North – South Commuter Railway (NSCR) Project (Malolos – Tutuban) Package CP01: Elevated Structures, 7 Stations and Depot			
ITEM NO.	REFERENCE CLAUSE/ SECTION	CLARIFICATION REQUEST	RESPONSE
<i>General</i>			
1	All Stations and Mainline Traction Substation	<p><u>Reference:</u> <i>Water Incoming Supply (All 7-Stations & Mainline Traction Substation)</i></p> <p>Please specify the location of tapping point from Maynilad water main supply to main water meter box of buildings. Our understanding is that the incoming shall be 1 meter from the said water meter box shown in each building. Please confirm. This is for all stations and mainline traction substation (MTS 1~6)</p>	<p>Complete water supply and distribution system shall be provided by the CP01 Contractor. Please refer to all relevant Technical Specifications and Drawings in the Bidding Documents in this regard.</p> <p>Further, the exact location of tapping points shall be determined by the Contractor during construction. The Contractor shall submit a proposal for approval of the Engineer before execution of works.</p>

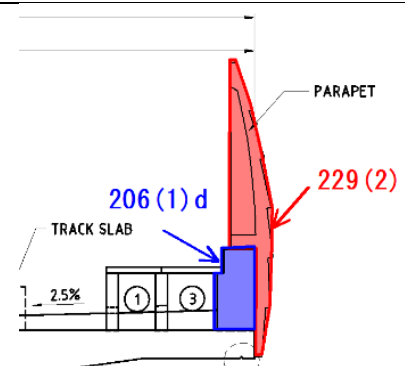
TS 700			
35	TS 700	<u>Reference:</u> <i>CATV System</i> Kindly confirm if CATV System is included on our scope. If yes, please provide plans.	CATV System for OCC building is within the scope of works of the CP01 Contractor. Please refer to TS 700, Clause 709.
36	TS 700	<u>Reference:</u> <i>Grounding System for the Traction Power equipment</i> Please confirm if the Grounding System for the Traction Power equipment will be part of our scope.	The Grounding System for the Traction Power Equipment is not within the Scope of Work of CP01. The CP01 Scope of Work is until the grounding bus bar only. However, necessary interface shall be done with other interfacing Contractors by the CP01 Contractor as per GS 100, Clause 126 and Appendix 4.

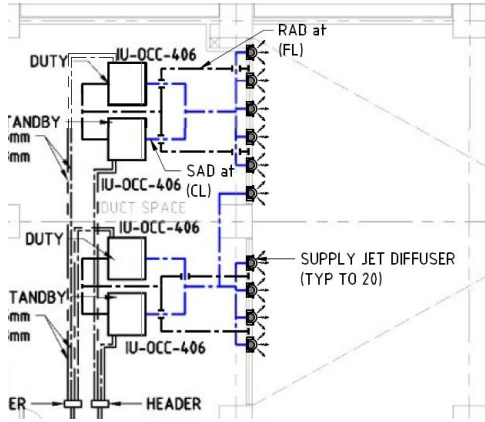
164	Page CP01-B8-116	<u>Reference:</u> <i>Light Repair Shop – Feeder System</i> Please provide load schedule for LRS-MDB-1 to 4.	Please refer to tabulated data in Book 8 of 11, Page CP01-B8-116.
165	Pages CP01-B8-116, CP01-B8-117 and CP01-B8-119	<u>Reference:</u> <i>Panel Detail</i> Please provide layout location for panels LPE-01, LPE-02, LPE-03, and LPE-04.	Please refer to the drawing in Book 8 of 11, Page CP01-B8-128.
166	Page CP01-B8-116, CP01-B8-117 and CP01-B8-119	<u>Reference:</u> <i>Panel Detail</i> Panels LP13, LP-14, LP-15 and LP-16 are included in layout but are not included in single line	Panels LP-13, LP-14, LP-15 and LP-16 shall be deleted from the layout.
